SUBJECT: HOPE CREEK INDEPENDENT DESIGN VERIFICATION PROGRAM (IDVP)
OBSERVATION REPORTS

LSP-29
May 8, 1985
Project No. 7212-30

Public Service Electric and Gas Company
Hope Creek Generating Station - Unit 1

Independent Design Verification Program
Observation Reports

As Shown on Drawing

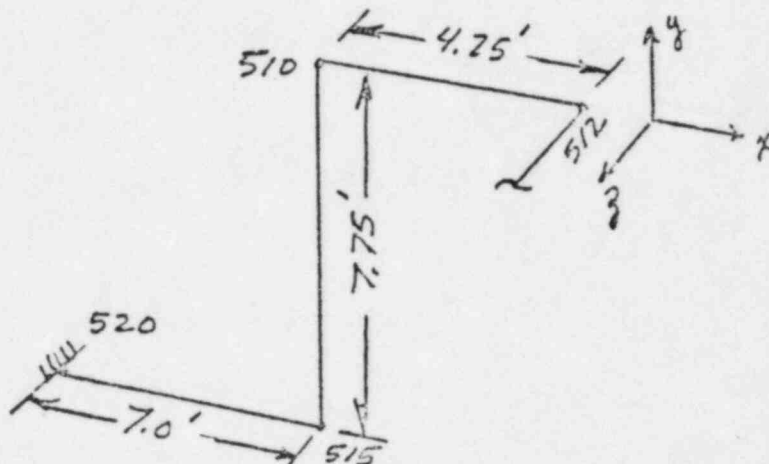
1. Structure(s), system(s), or component(s) involved:
Calculation No. C-1750-3Q, dated 2/13/84, Safety Auxiliary Cooling System Piping.
2. Description of Observation:
In calculation C-1750-3Q, the computer model of line 155-HBC-30, from node 512 through node 520 does not appear to agree with the routing shown on drawing HG-1-P-EG-13, Revision 10D, dated 2/1/84.
(continued on next page)

In the computer analysis, the line is modeled as a span of 4.25 feet from node 510 north to node 512 (X direction), followed by a span of 7.75 feet downward to node 515, followed by a seven foot span north to the anchor at node 520.

Drawing HG-1-P-EG-13 shows a downward span of twelve feet from nodes 510 to 515, followed by a span of seven feet north to the anchor at data point 520 with no 4.25 foot span in the X direction from node 510.

4. Recommendation for resolution (optional):
 - a. Provide justification that the discrepancy in the computer model has been reconciled with the design drawing.

- b. Provide assurance that other piping stress analyses have been reconciled with the design drawings.
5. Internal Review Committee classification of Observation:
 Not significant to safety (See Item 6)
 x Additional information required (See Item 6)
 Potentially Significant to Safety (See Item 8)
